SUNSET VILLAGE FILING NO. 4

CONSTRUCTION PLANS

EPC STORMWATER REVIEW COMMENTS
IN ORANGE BOXES WITH BLACK TEXT

MODIFIED FOR S.I.A. CD SET
RICHARD D. LYON, PE
ATWELL, LLC
DECEMBER, 2021
EPC PROJ.: CDR-21-008

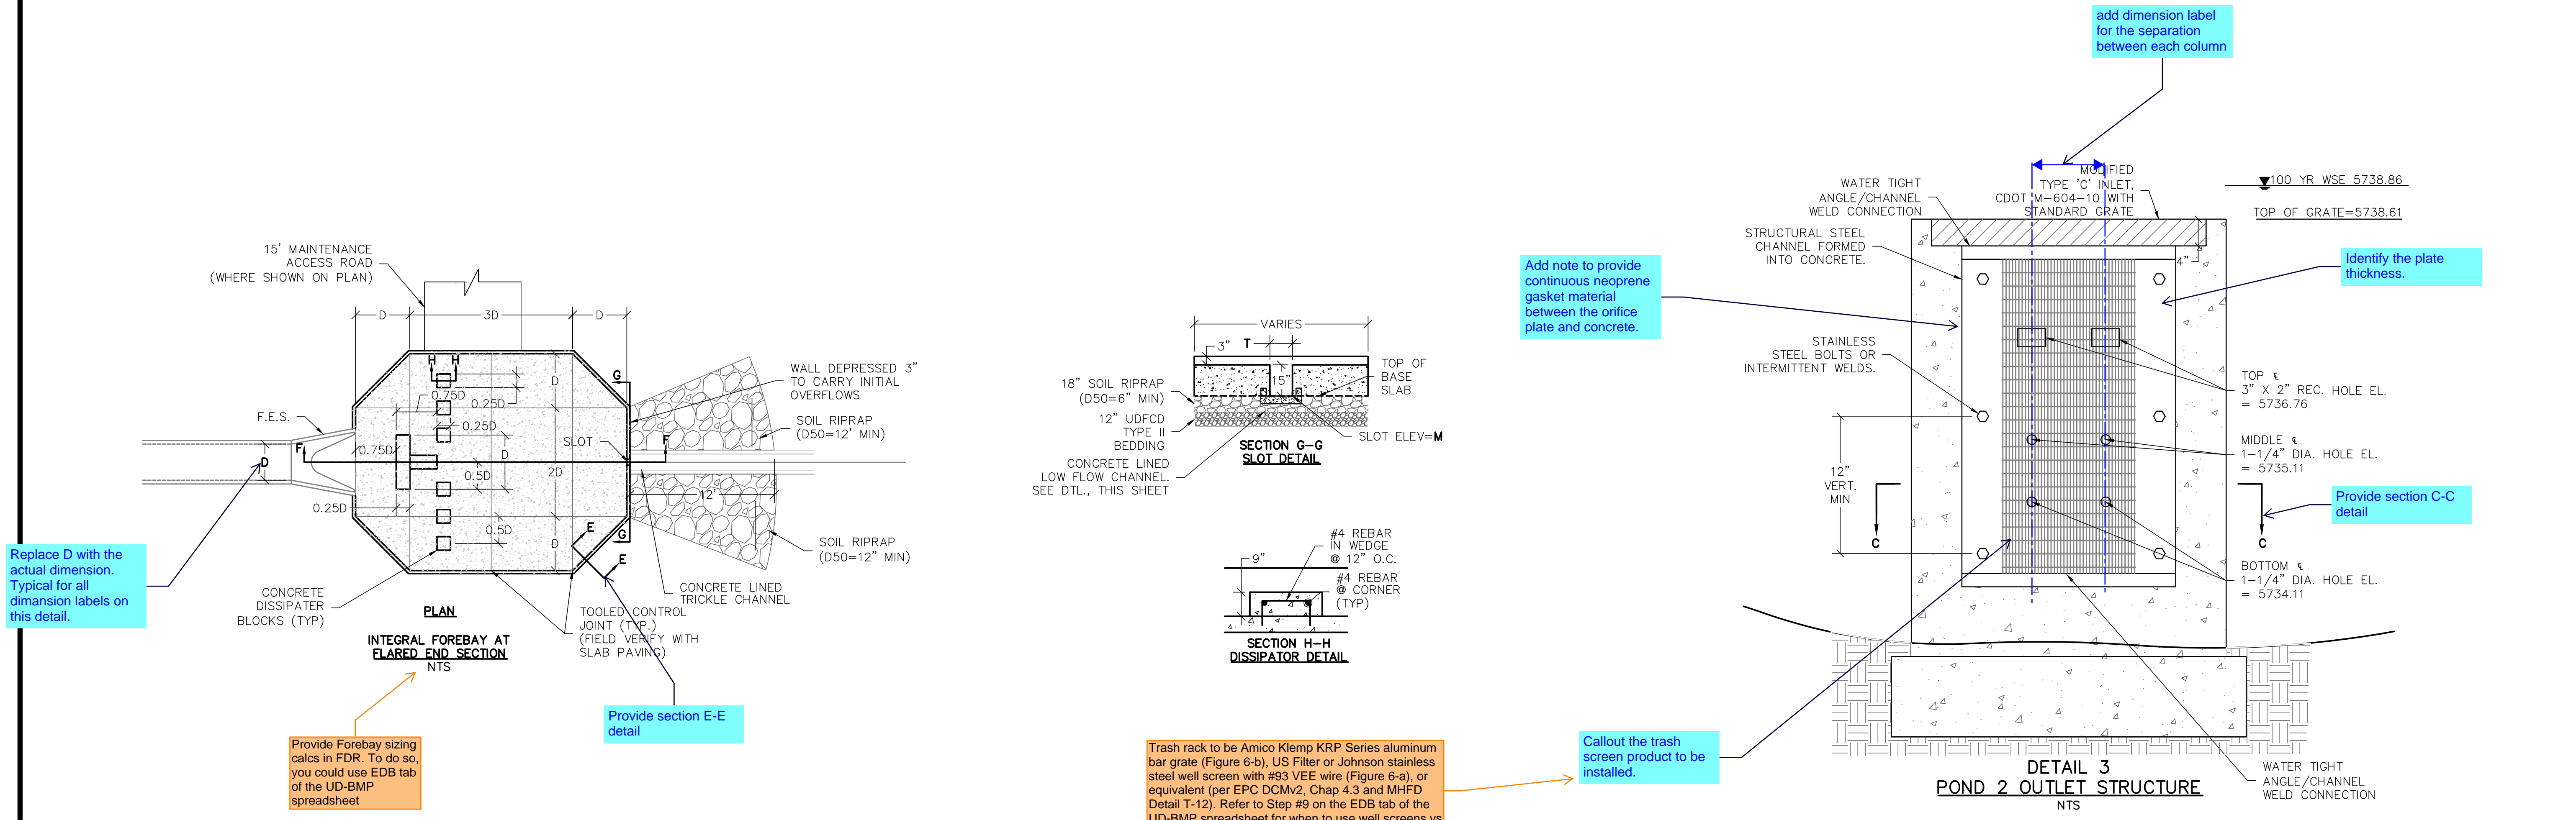
Replace D with the actual dimension. Typical for all dimension labels on this detail.

Provide Forebay sizing calcs in FDR. To do so, you could use EDB tab of the UD-BMP spreadsheet

Provide section E-E detail

Add note to provide continuous neoprene gasket material between the orifice plate and concrete.

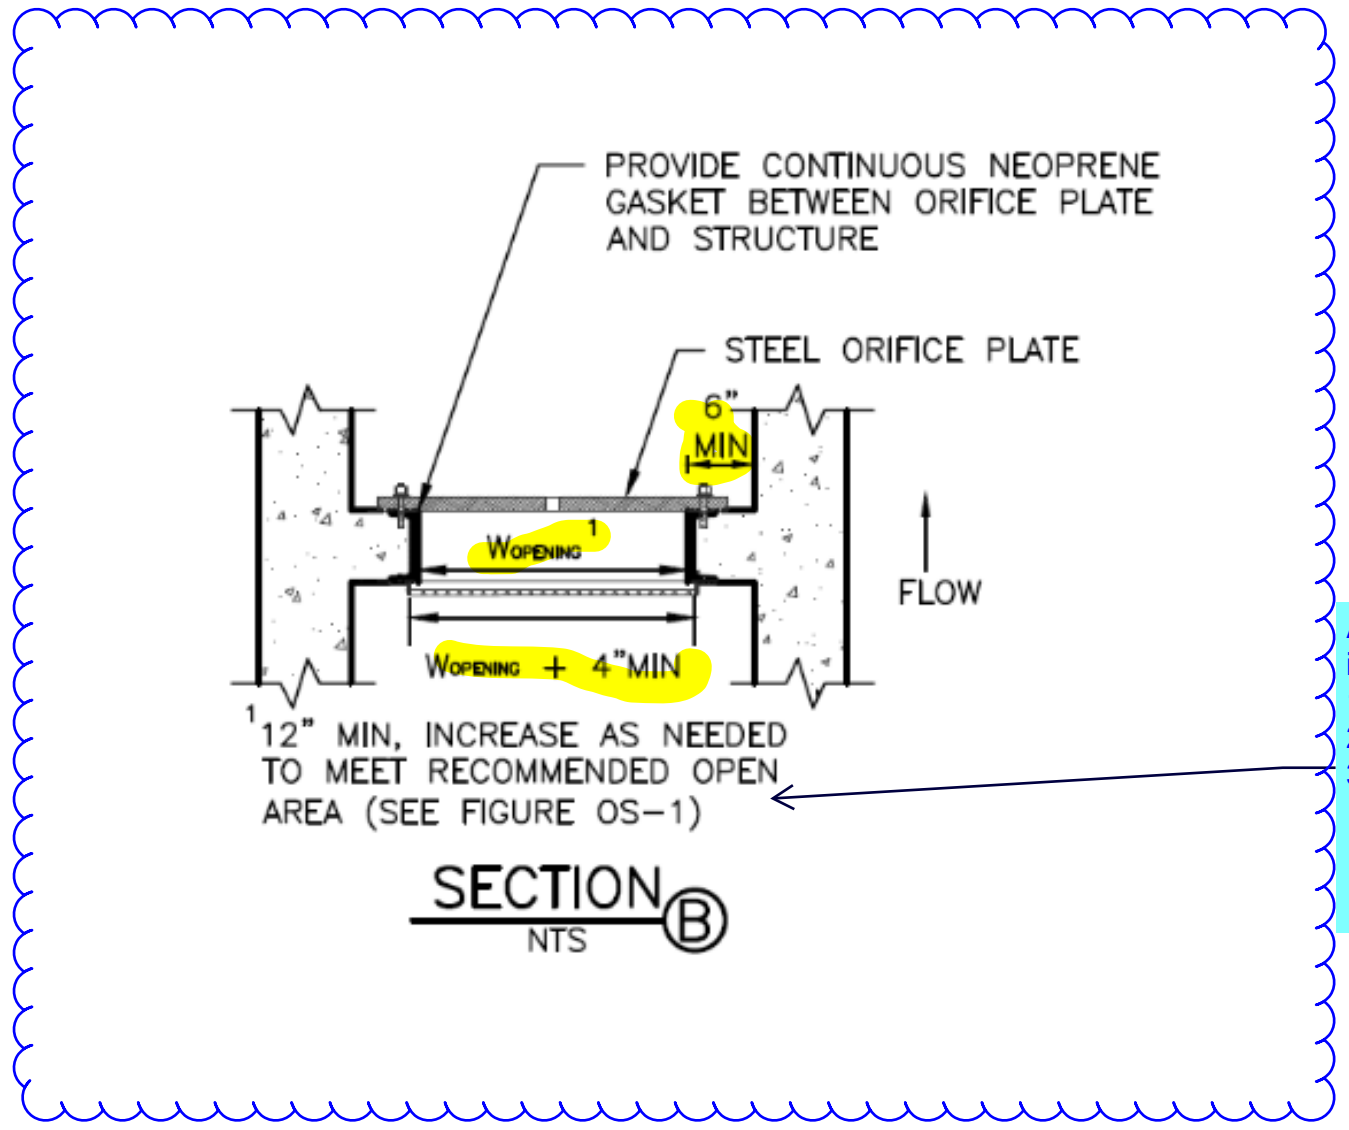
add dimension label for the separation between each column

Identify the plate thickness.

Provide section C-C detail

Trash rack to be Amico Klemp KRP Series aluminum bar grate (Figure 6-b), US Filter or Johnson stainless steel well screen with #93 VEE wire (Figure 6-a), or equivalent (per EPC DCMv2, Chap 4.3 and MHFD Detail T-12). Refer to Step #9 on the EDB tab of the UD-BMP spreadsheet for when to use well screens vs bar grates.

Add this detail or update the existing details to include the following information:
1. Identify the width of the opening
2. Width of the trash screen
3. Width of orifice plate.
